**Economic Commission for Europe****Inland Transport Committee****World Forum for Harmonization of Vehicle Regulations****Working Party on Lighting and Light-Signalling****Ninetieth session**

**UN Regulations on Light Sources and the Consolidated Resolution  
on the Common Specification of Light Source Categories****Proposal for Amendment [x] to the Consolidated Resolution  
on the common specification of light source categories (R.E.5)****Submitted by the Task Force on Substitutes and Retrofits\***

Sheet H11\_LED<sub>r</sub>/3, replace by a new sheet H11\_LED<sub>r</sub>/3, to read:

Figure 4

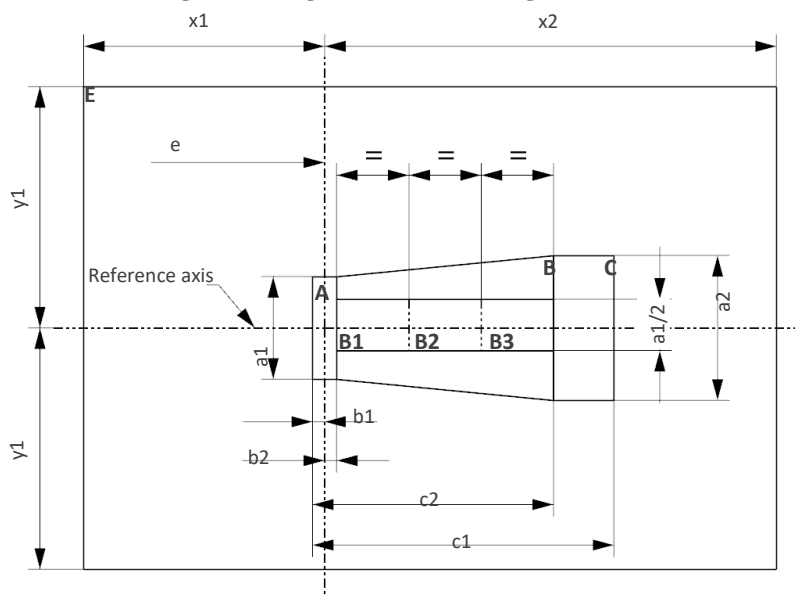
In case of Configuration-1 the position of the light emitting area is checked by a box system defined in Figure 4 when operated at test voltage, which shows the projections when viewing from B (see sheet H11\_LED<sub>r</sub>/1, Figure 1) and from A and –A (see sheet H11\_LED<sub>r</sub>/1, Figure 1), i.e. along the C-planes C<sub>0</sub>, C<sub>90</sub> and C<sub>270</sub> (as defined in Figure 6).

In case of Configuration-2 the position of the light emitting area is checked by a box system defined in Figure 4 when operated at test voltage, which shows the projections when viewing from A and –A (see sheet H11\_LED<sub>r</sub>/1, Figure 1), i.e. along the C-planes C<sub>90</sub> and C<sub>270</sub> (as defined in Figure 6). The distance z between the surfaces of the opposite light emitting areas shall not exceed 2.9 mm.

In both configurations, the proportion of the total luminous flux emitted into these viewing directions from the area(s) as defined in Figure 4:

- Total box area:  $(A+B+C) / E$  shall be not less than 90%
- Area A:  $A / (A+B+C)$  shall be not more than 10%
- Areas B<sub>1</sub>, B<sub>2</sub> and B<sub>3</sub>:  $B_1/B$ ,  $B_2/B$ ,  $B_3/B$  shall each be not less than 15%
- Area B:  $B / (A+B+C)$  shall be not less than 72 %
- Area C:  $C / (A+B+C)$  shall be not more than 22%
